Product Change Notification

113375 - 00

Change Notification #: 113375 - 00
Change Title: Intel® Server System R2312GZ4GC4
PCN 113375-00, Product Design
Add Ground Stubs, Update System Rear Panel,
750W Common Redundant Power Supply and
BIOS/ME/BMC/FRUSDR Firmware
Date of Publication: November 05, 2014

Figure One

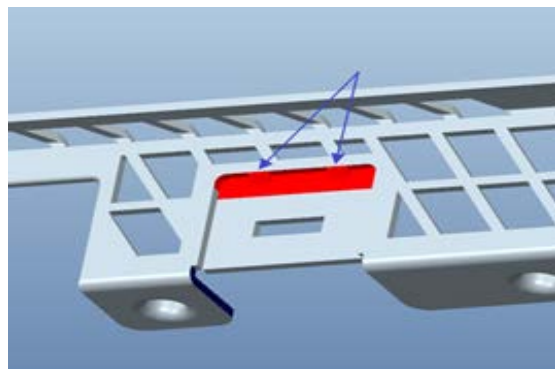
1. Update the one big center joint to two smaller joints so that the joints will not conflict with the LAN cable connector latch. See the Figure One.

Figure Two

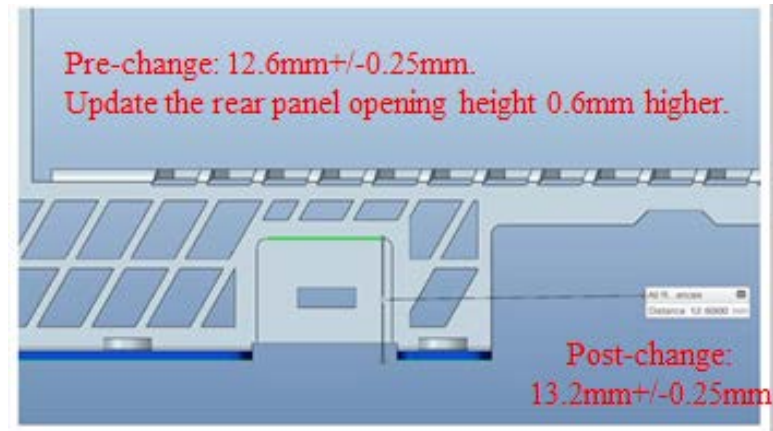
2. Update the rear panel opening height 0.6mm higher to improve the flexibility for the cable latch. The previous height was 12.6mm \pm 0.25mm. The updated height is 13.2mm \pm 0.25mm. See the Figure Two.

Figure Three

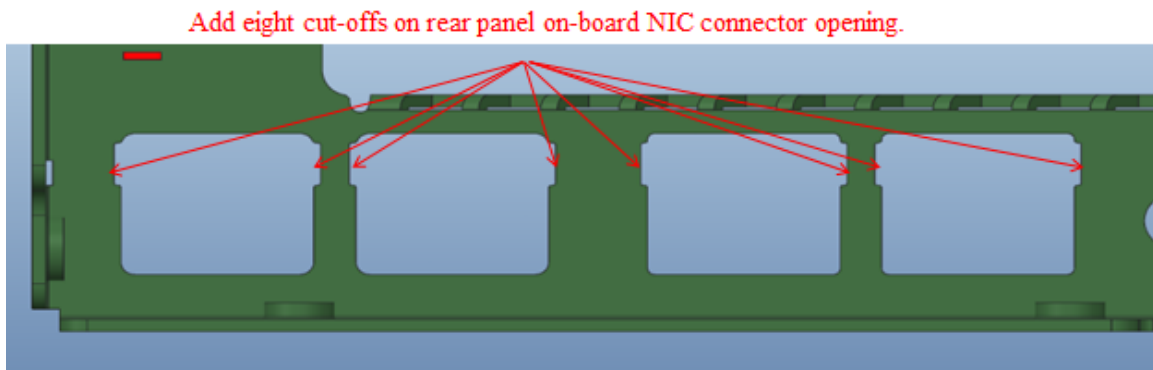
3. Add eight cut-offs around the on-board NIC (Network Interface Controller) openings to improve the LED visibility. See the Figure Three.
